DISCUSSION BEFORE THE WIRELESS SECTION, 2ND MARCH, 1932.

FIG. A.

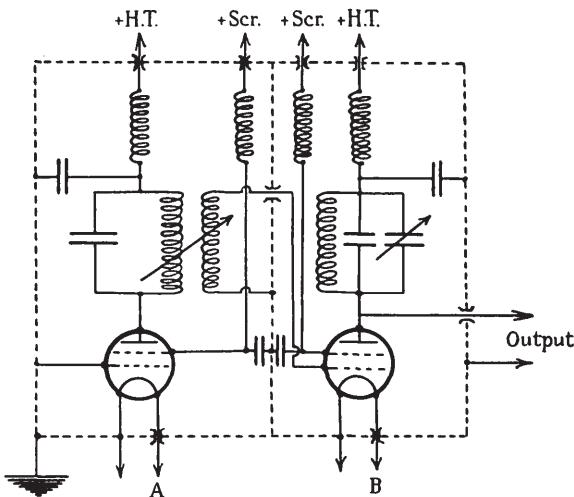
industry, would also carry out research on subjects of interest to the industry as a whole. Passing on now to the paper, the author's primary object was to localize between the input terminals of a receiver a known minute modulated radio-frequency voltage. We must consider not only circuit details but also the mechanical arrangement of the entire system, as on this factor depends the elimination of a number of stray voltages whose presence would defeat the object in view. A comprehensive analysis of this question has been given by J. R. Bird.* I should like to ask the author whether he has used the dynatron oscillator as either a modulated radio-frequency or a beat-frequency oscillator. The results which I obtained some time ago on the simple dynatron oscillator confirm those recently published by F. M. Colebrook.† I further found that this type of oscillator could very easily be modulated by applying the modulation voltage to the control grid. These experiments led me to suggest the design for a beat-frequency oscillator shown in Fig. A. It consists of two dynatron oscillators A and B; A oscillates at a

fixed frequency, while the natural frequency of B can be varied within 10 kilocycles per sec. of that of A. Further, B is modulated at the frequency of A, so that the output from B is of the desired beat frequency: this is rectified, filtered, and amplified in the usual way. Has the author investigated any experimental methods of checking attenuator output voltages? The best method appears to be to connect two dissimilar attenuators in cascade; on increasing the attenuation of one and decreasing that of the other by the same amount, any change of output could easily be detected on a calibrated receiver. The validity of the method rests upon the fact that the two attenuators would not have compensating errors. I am very sceptical about calculated outputs, as we do not know what stray effects are present. In the case of mains receivers we are faced with another possible input, namely via the mains leads and high capacitance between the mains transformer and the rest of the wiring. Some test will have to be devised to investigate this effect, and I should be glad of the author's views on the matter. In conclusion, I would point out that the modulation percentage used by the Americans is 30, and not 40 as stated in the paper.

I am glad that Mr. Oliphant appreciates the object of the paper, namely, to stimulate interest in the standardization of test procedure. Regarding his remarks on the dynatron oscillator, I would point out that

certain rough tests have been made on it and that this type of circuit appears to be quite satisfactory. The testing apparatus was constructed, however, before this work was completed and hence the dynatron oscillator has not been used. Doubtless, if more work were done, the dynatron oscillator might be shown to be preferable to the present triode generator. I am indebted for his correction of my figure of 40 per cent modulation.
